# Urban Design Observations

**Application ref:** DM/23/2866

**Address:** Land East Of Ansty Way, Cuckfield Bypass, Cuckfield, West Sussex

**Stage:** Outline planning application (All matters reserved except for access)

Also Dwg: *CYCLE ROUTE IMPROVEMENT PLAN (SHEET 1) in doc: Designers Response Cycle Scheme\_2207280-R16* Doesn't show the proposed shared foot/cycleway to continue to Ansty.

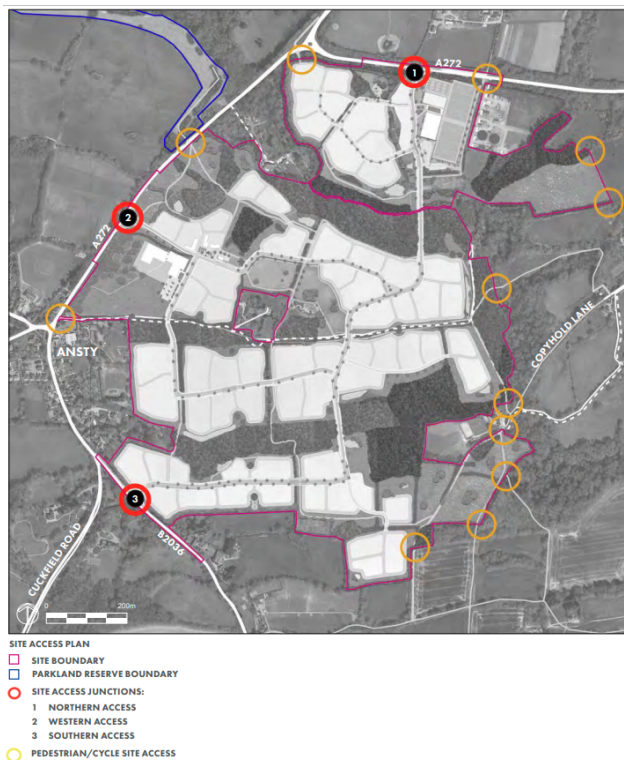
Comments: It appears that the proposed pedestrian footpath ends abruptly and is not connected to the existing footpath on the north-west side of the A272. This Signalised crossing would be recommended if the two were to connect. The existing footpath leading to Ansty is very narrow and, it would benefit from being included in the plans for widening.
